APPROVAL <i>Slw</i>	REQUEST FOR COUNCIL ACTION	MTG. DATE 11/21/2017
Reports & Recommendations	A RESOLUTION AUTHORIZING CERTAIN OFFICIALS TO EXECUTE A SUBDIVISION DEVELOPMENT AGREEMENT FOR PARK CIRCLE CONDOS LOCATED AT APPROXIMATELY 9733 SOUTH 76TH STREET	ITEM NO. <i>G.6.</i>

**CITY OF FRANKLIN****REPORT TO THE PLAN COMMISSION****Meeting of November 9, 2017****Special Use Amendment**

Project Name:	The Lakeview at Franklin Apartments
Project Location:	3709 West College Avenue
Property Owner:	McKowen Family Partnership, LLLP
Applicant:	Herman & Kittle Properties, Inc.
Agent:	David Thompson, Herman & Kittle Properties, Inc.
Current Zoning:	R-8 Multiple-Family Residence District
2025 Comprehensive Plan:	Residential – Multi-Family
Use of Surrounding Properties:	Single-family residential (City of Greenfield) to the north, vacant Milwaukee County land (Grobschmidt Park & Mud Lake) to the south, multi-family residential to the east and single-family and multi-family residential to the west
Applicant's Action Requested:	Approval of the Special Use Amendment to allow construction of the Lakeview at Franklin apartment development

Planting Plan

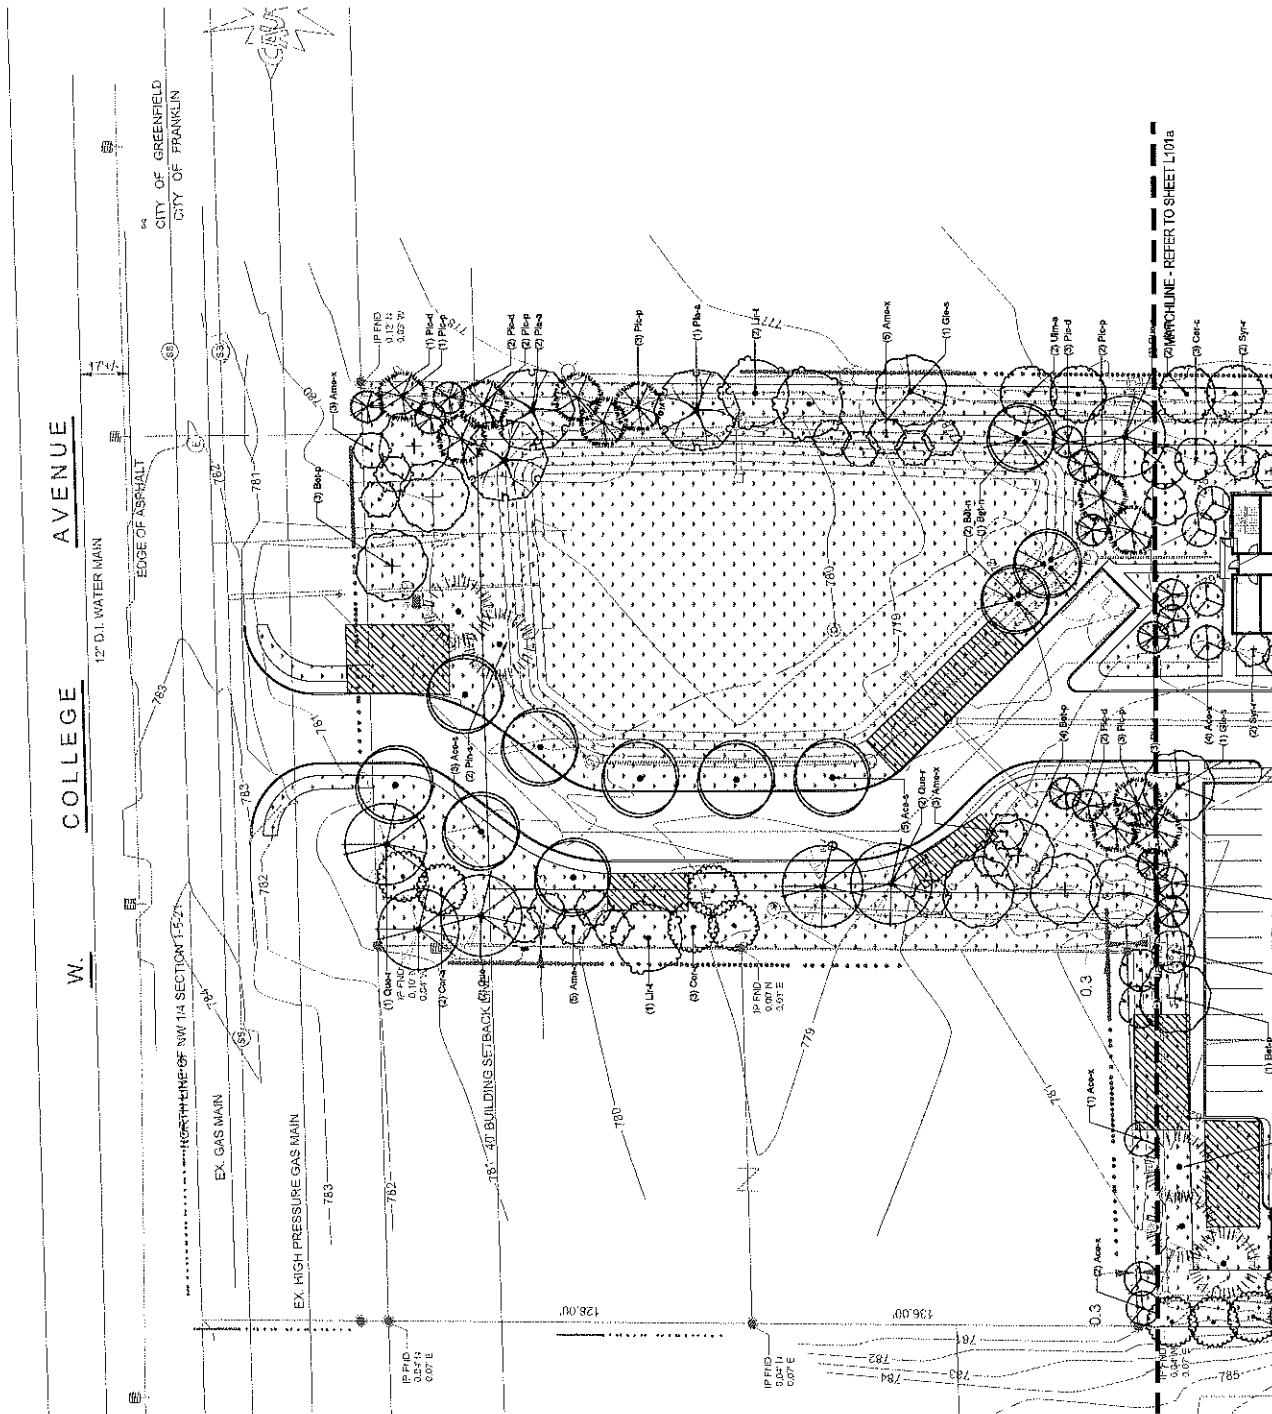
10. The Landscape Plan incorrectly states the quantity of Canopy/Shade Trees required by the UDO. Table 15-5.0302 requires a minimum of 1.5 trees per dwelling unit; therefore, 72 Canopy/Shade Trees are required (1.5 x 48). 87 Canopy/Shade Trees are required when factoring in the additional 20% for the bufferyard. Please revise the notes on the Landscape. Staff also recommends providing an additional 48 Canopy/Shade Trees to be in compliance with the UDO minimum landscape standards.

11. Staff recommends additional plantings be installed on the west side of the property, adjacent to the existing condominium development.

12. Please move the text noted below on the Landscape Plan, Sheet L101, so that it does not cover up the plant labels.

13. Staff recommends noting a 2-year plant replacement guaranty on the Landscape Plan per Section 15-5.0303G.3. of the UDO.

14. Staff recommends that irrigation be provided in compliance with Section 15-5.0303D. of the UDO. The type of irrigation provided must be noted on the Landscape Plan.

15. Please provide a Snow Storage Plan in accordance with Section 15-5.0210 of the UDO. Staff recommends illustrating the areas for snow storage on the Landscape Plan.

Notes have been adjusted to reflect the correct equation. The updated landscape plan includes 87 Canopy/Shade trees as required by the UDO (Sheets L101a, L102a, and L110a) Please note that the 87 trees include 78 new trees and the assumption of 9 trees to be preserved in the conservation easement, to be confirmed by a tree study. However, HKP would like to also present an alternative Landscape Plan for review by Plan Commission as well, which includes 40 new planning trees (Sheets L101, L102, and L103). While it is possible to meet the code, HKP does not find this density of trees to be appropriate for the site or the health of the trees.

Due to retaining wall addition and utilities, all trees along the west edge of the garages have been relocated. (Trees cannot survive in the backfill material of the wall) The wall is approximately 4' tall, with the new construction on the low side of the grade. Shrubs and ornamental grasses have been added along the top of the wall to soften the building from the Homes on the Park Condominium residents. Trees that were originally along this west edge of the property have been relocated to other locations on site that do not have utility and wall conflicts.

A 2-year plant warrantee period has been changed in note 12 on L101 and L102.

An irrigation note has been added to the plans. Refer to note #17. This indicates the irrigation system will be designed and constructed by the Contractor.

3,390 s.f. of snow pile storage areas have been identified on the plans. This is a little more than 10 percent of the parking lot area and drive.

Replant: add 15 canopy trees + 10 evergreen trees + 10 decorative trees + 25 shrubs along south border/park, use

Provided: an additional 15 canopy trees + 10 evergreen trees + 10 decorative trees = 29
